Millennium-Playa Del Mar Apartments Project Final Environmental Impact Report

State Clearinghouse Number 2006101014

County Project Number R2009-02015

Final Environmental Impact Report
MILLENNIUM-PLAYA DEL MAR
APARTMENTS PROJECT

FIGURE 4.5-4

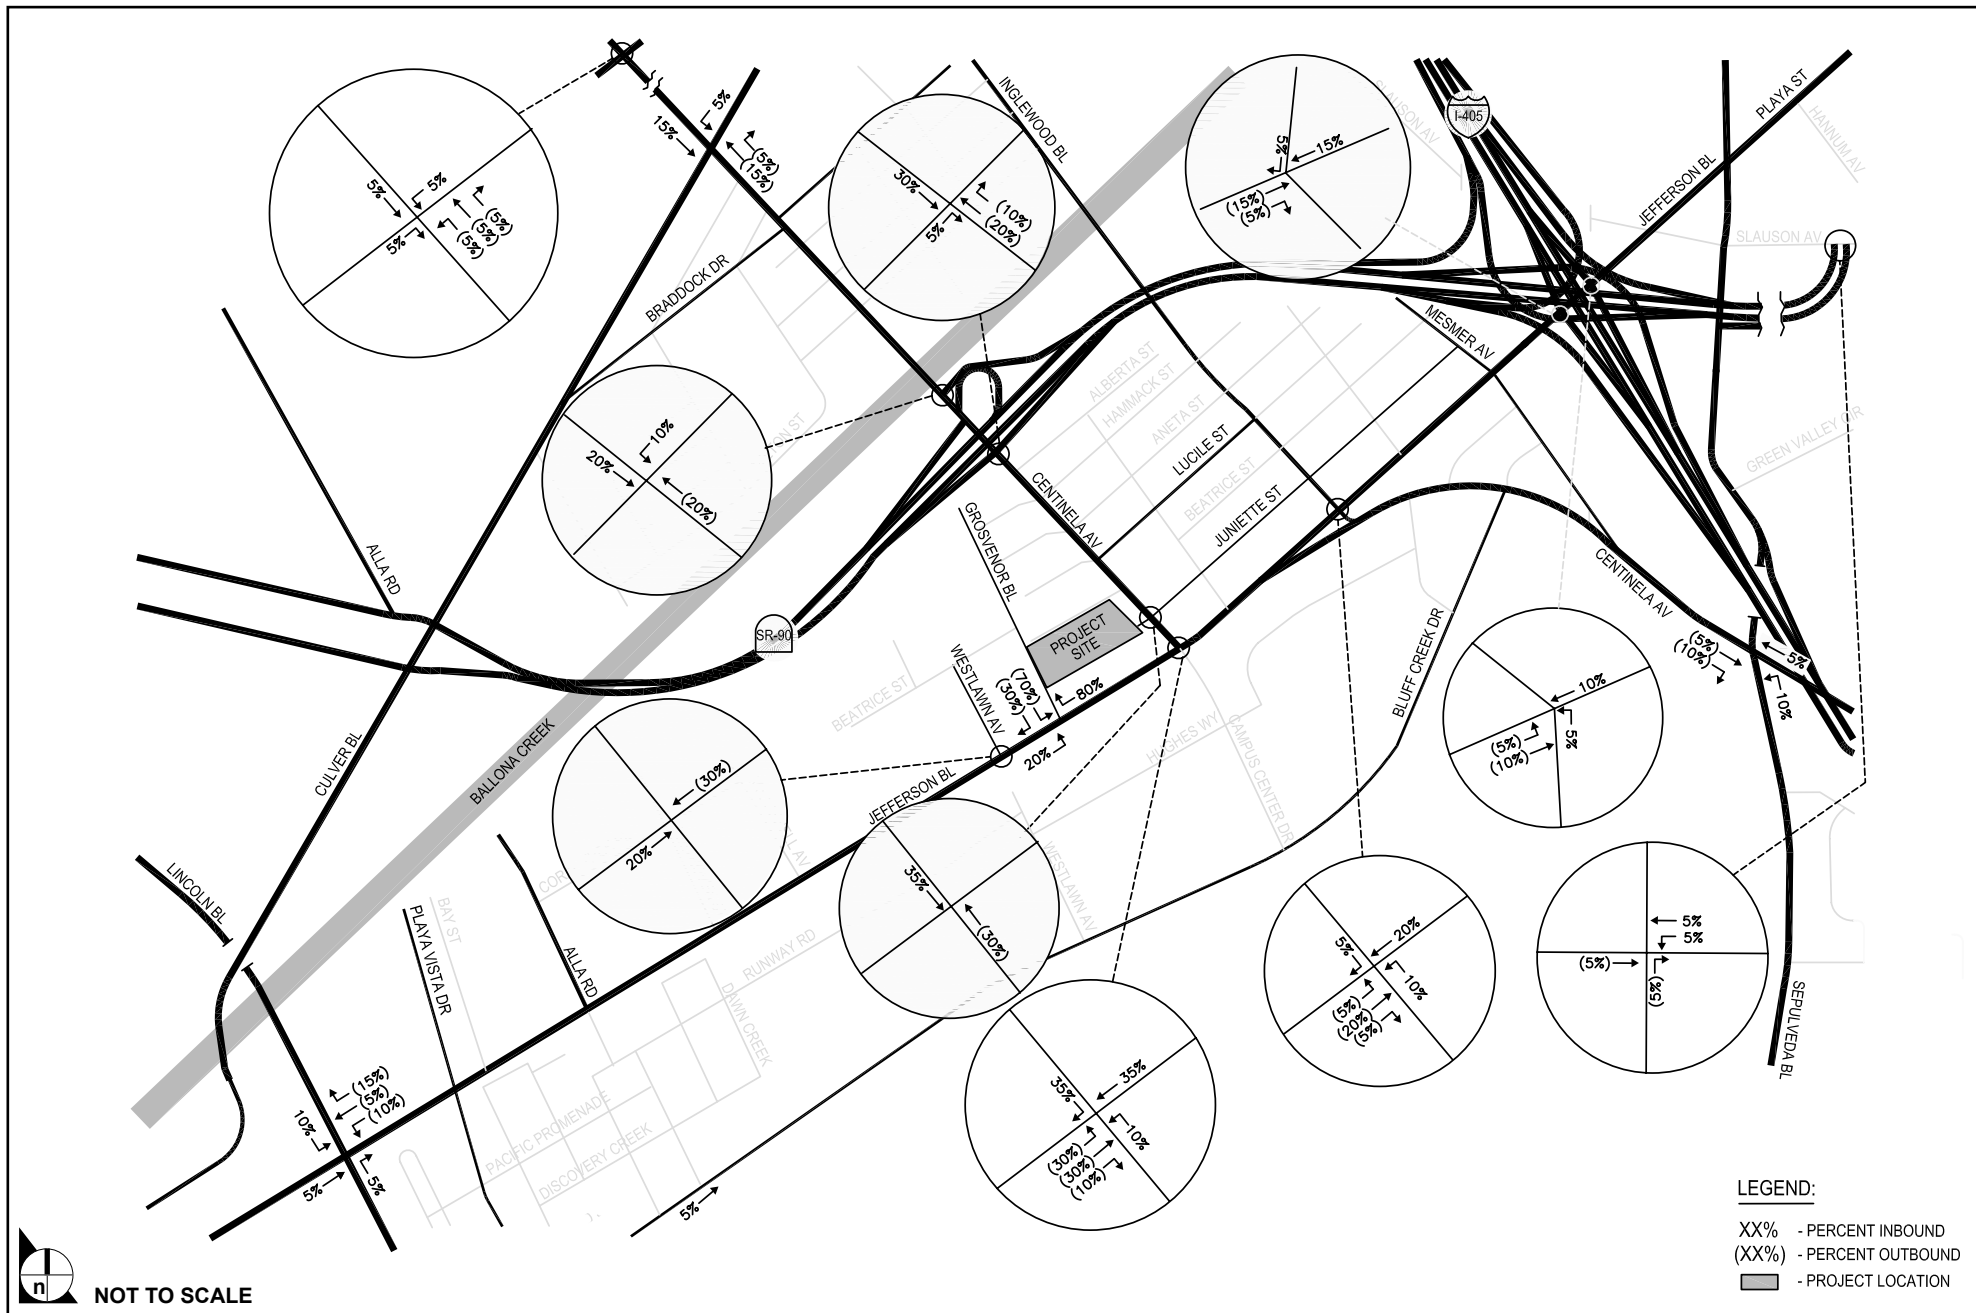
The following section and figure within Section 4.5 Traffic and Access of the Recirculated Draft EIR have been revised:

4.5.4.3.7 Future Year 2013 Base Conditions Plus Project Traffic Volumes
